**Report Type:** CC Access Report  
**Reference Number:** 20074 A  
**Client:** Barbara Tarnawski Architects  
**Site Address:** Platypus Playground Children's Centre  
61 Wardell Drive  
South Penrith

# ACCESS REPORT

This Access Compliance Report is to accompany a Construction Certificate Application for the development proposed at Platypus Playground Children's Centre  
61 Wardell Drive, South Penrith.

This development proposes Additions and Alterations to an Existing building which operates as a child care centre. The development is within Penrith Council LGA.

[Image description: Proposed ground floor plan]

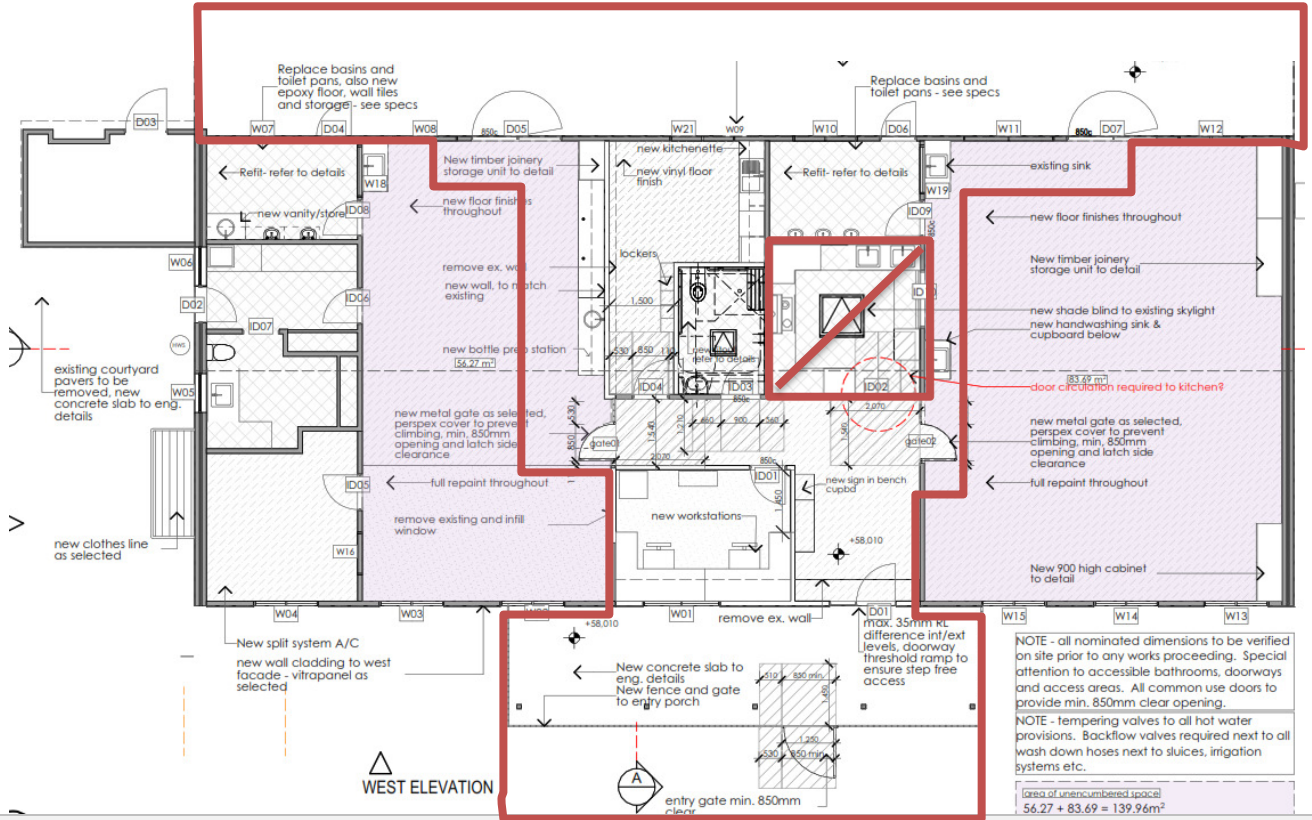
<b>Compliance Comments</b>	<p>Capable of compliance.</p> <p>As stated in the above requirements, APS only applies to,</p> <ul style="list-style-type: none"> <li>- New works,</li> <li>- Modified works and</li> <li>- Works within the 'affected part'</li> </ul> <p>In this development, the new works, modified works and works within the 'affected part' have been shown in the plan below with a red boundary and include:</p> <ol style="list-style-type: none"> <li>(a) New accessible car space and pathway leading to the childcare centre</li> <li>(b) New external verandah</li> <li>(c) New entry</li> <li>(d) New accessible WC and shower</li> <li>(e) New staff room</li> <li>(f) Fit out of existing WC's for the childcare children</li> </ol>

[Image description: Plan of outdoor car parking space above shows the provision of Accessible parking spaces]

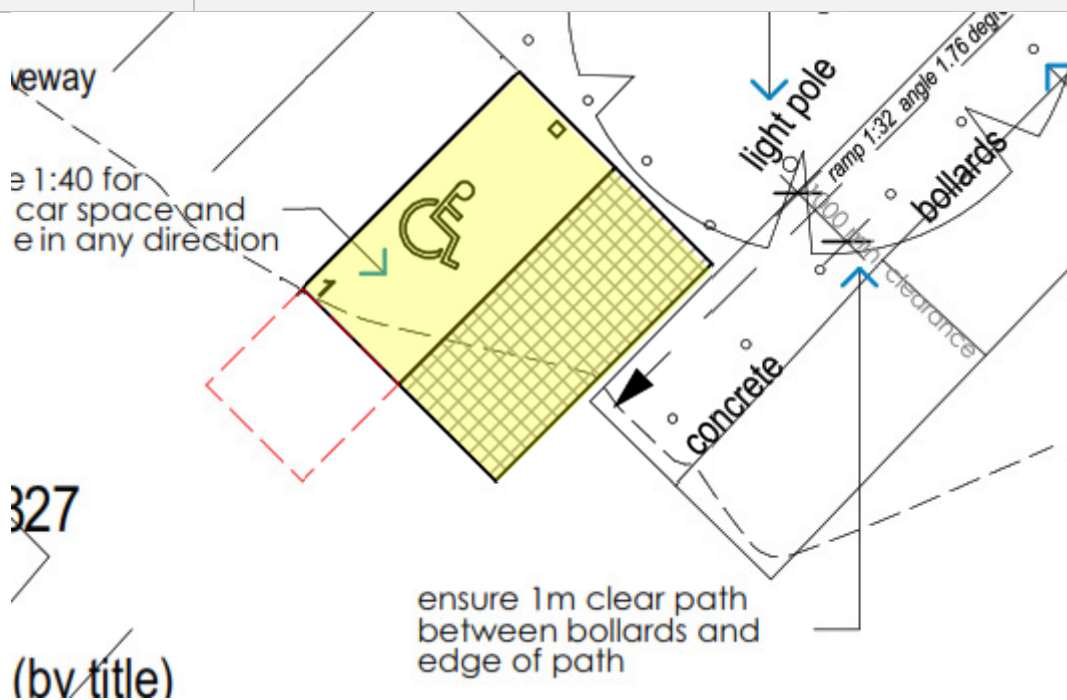
<b>Compliance Comments</b>	Complies. Total number of Accessible parking spaces required / provided in the development = 1
